FIELD INSPECTION

Project Name:	Mountain Valley Pipeline	Inspector:	Marshall Willis
Inspection Date:	Tuesday, February 19, 2019	Project Contact:	Brian Clauto
Spread I: Franklin County	STA 14062+17 – 14042+83 STA 14272+24 – 14274+00 STA 14129+00 – 14171+75	Weather (Wet/Dry/Rain):	Dry

FIELD INSPECTION PHOTO LOG

Fig. 2: **STA 14272+24** – Stabilization needed.

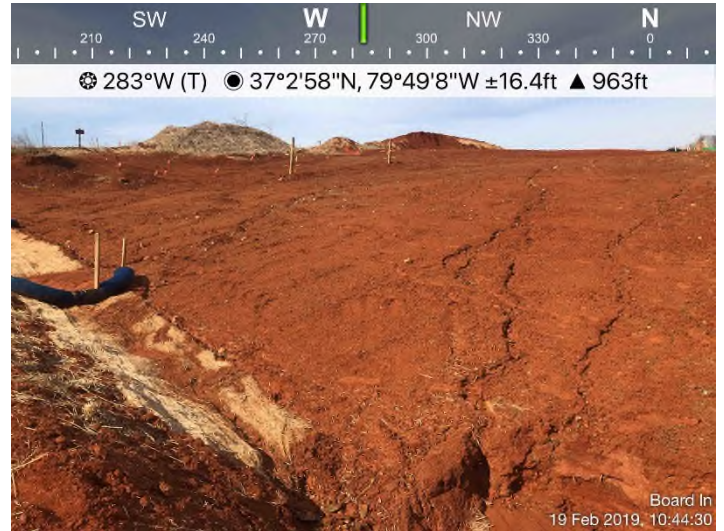
- Streams / wetlands inspected included: S-YZ4, S-YZ5, S-C8 and S-KL51.
- Waterbar does not have positive drainage at STA 14049+30.
- Further stabilization needed at STA 14272+24. Rill erosion evident.
- P1 and CFS need maintenance at STA 14273+25.
- SSF needs repair in ATWS 1478.
- Sump full at GAS S-C8.
- CFS needs maintenance at STA 14148+57.
- Stabilization needed adjacent to S-KL51.

Recommended Corrective Action: Maintain and install all controls per the approved plan and specs.
